**PROPOSAL FOR INCLUSION OF HIGH-INTENSITY DISCHARGE (HID)
HEADLAMPS IN REGULATION No. 113**

**IMMA proposal for adding a beam pattern for a high-intensity discharge lamp
to Regulation No. 113**

For Class E (Gas-discharge headlamp for motorcycles)

Figure C

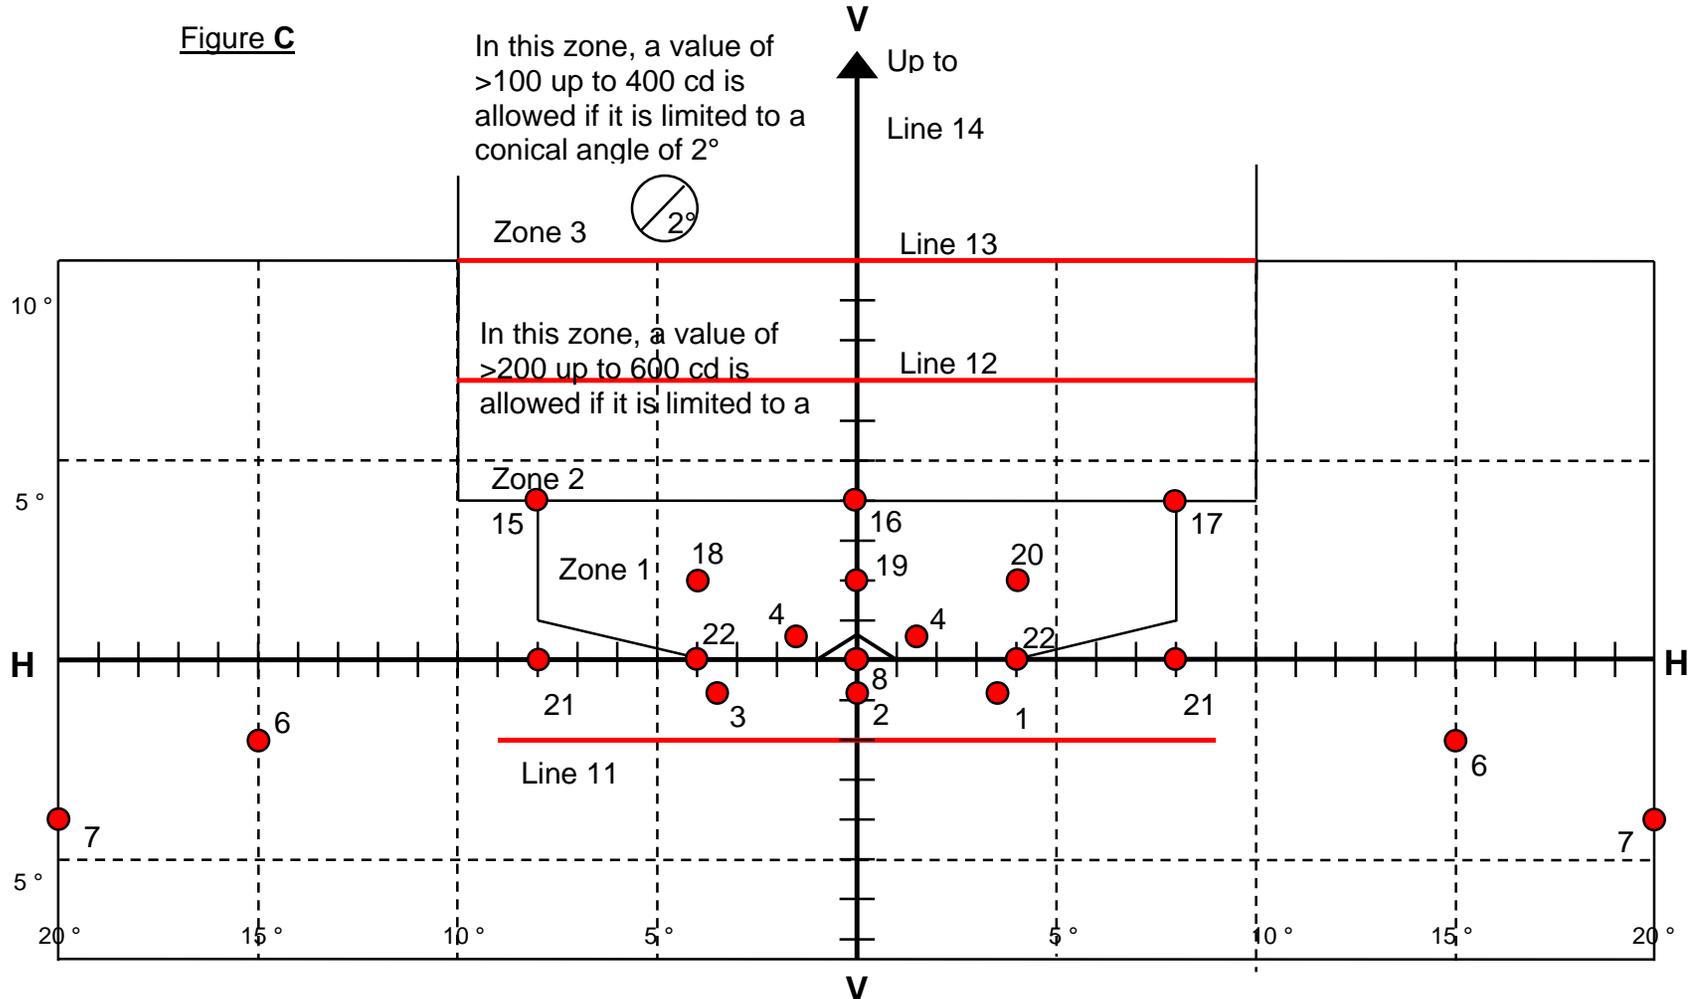
Passing beam measuring screen for **Class E** headlamps (Dimensions in mm with the screen at 25 m distance)

Note: The luminous intensity of zones 2 and 3 above are not applied to class E.

FIGURE D

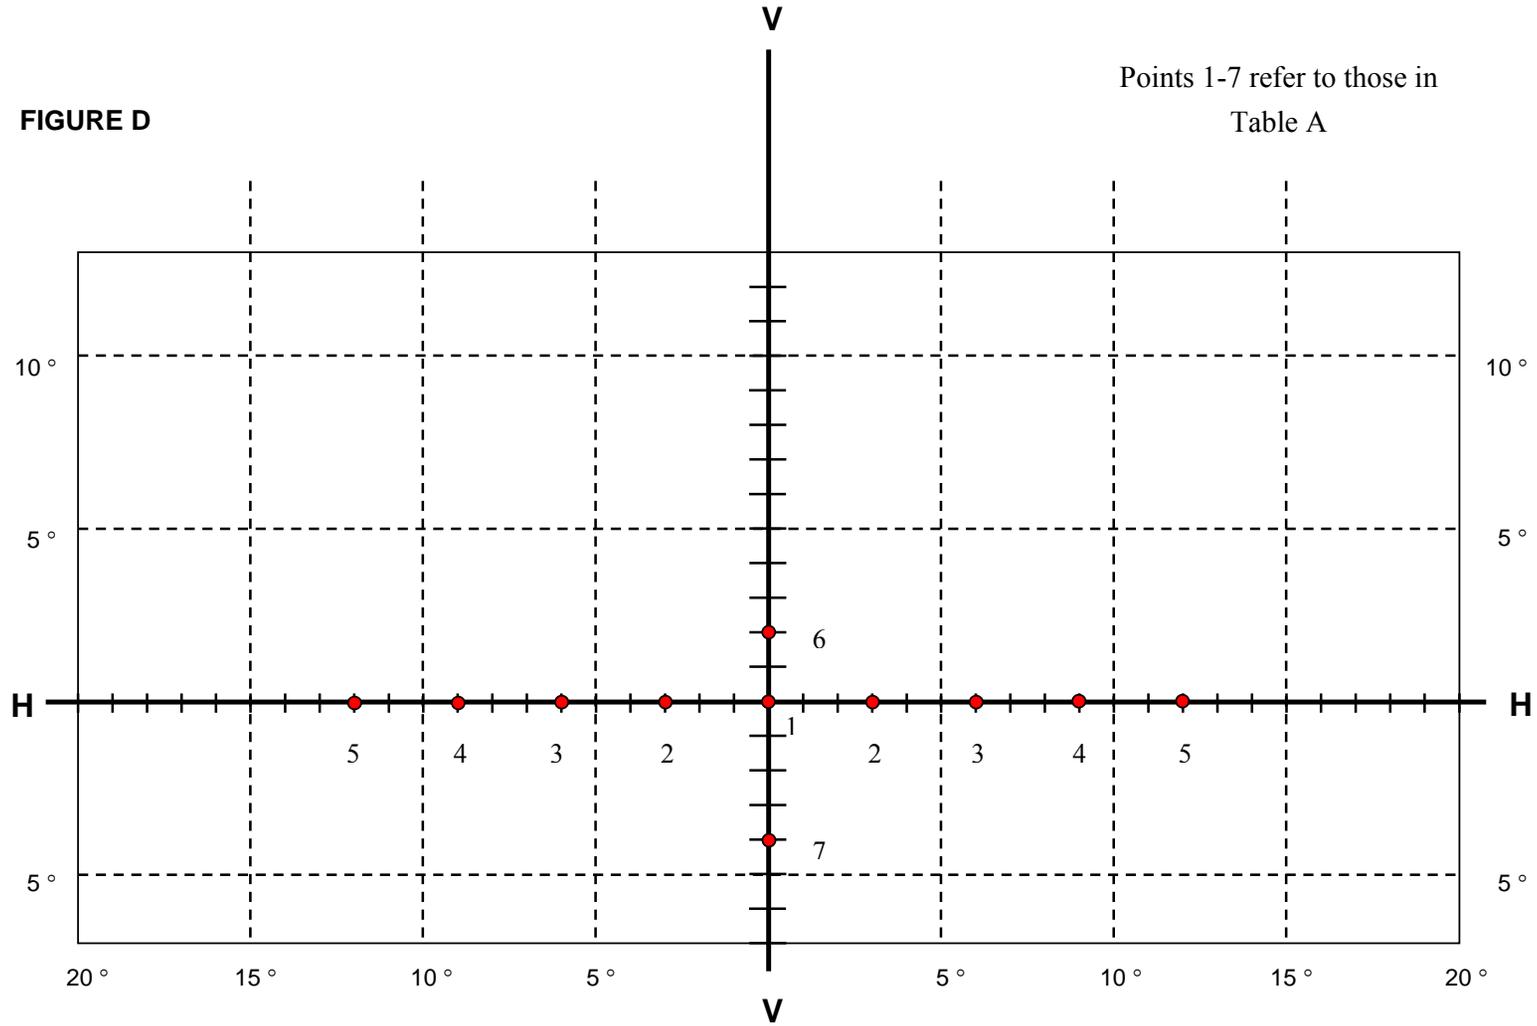
Primary main (high) beam proposal

Points 1-7 refer to those in Table A

FIGURE E

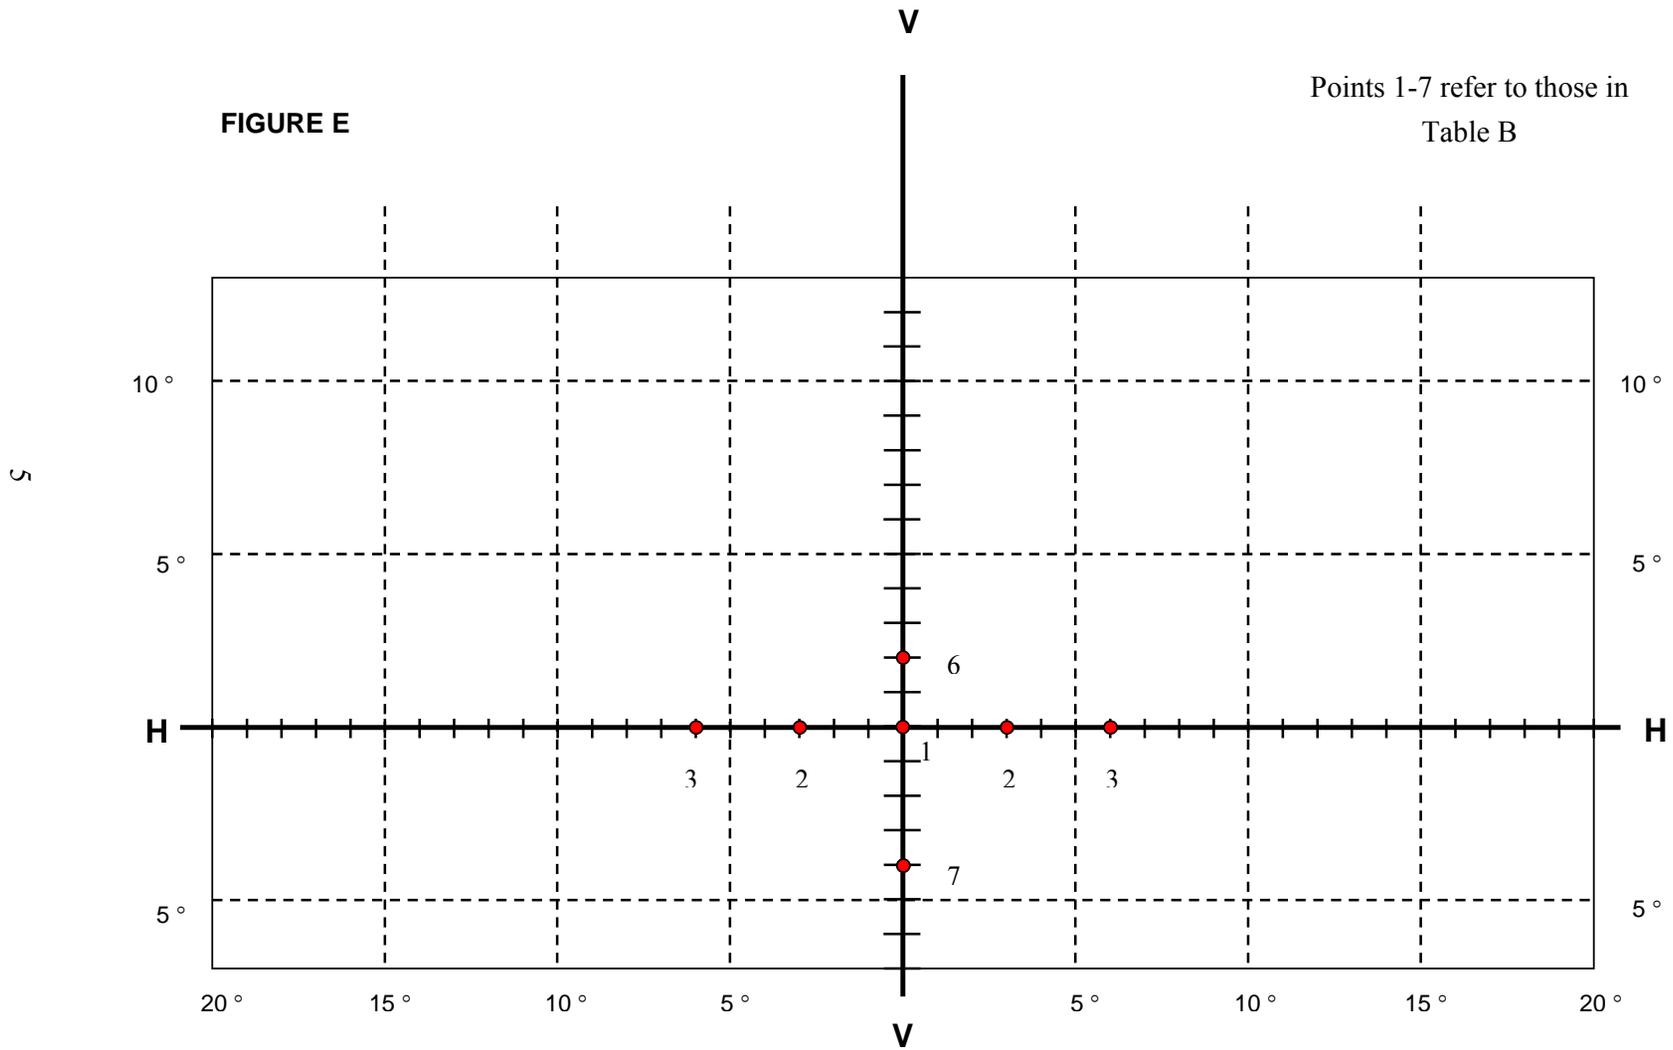
Secondary main (high) beam proposal

Points 1-7 refer to those in Table B
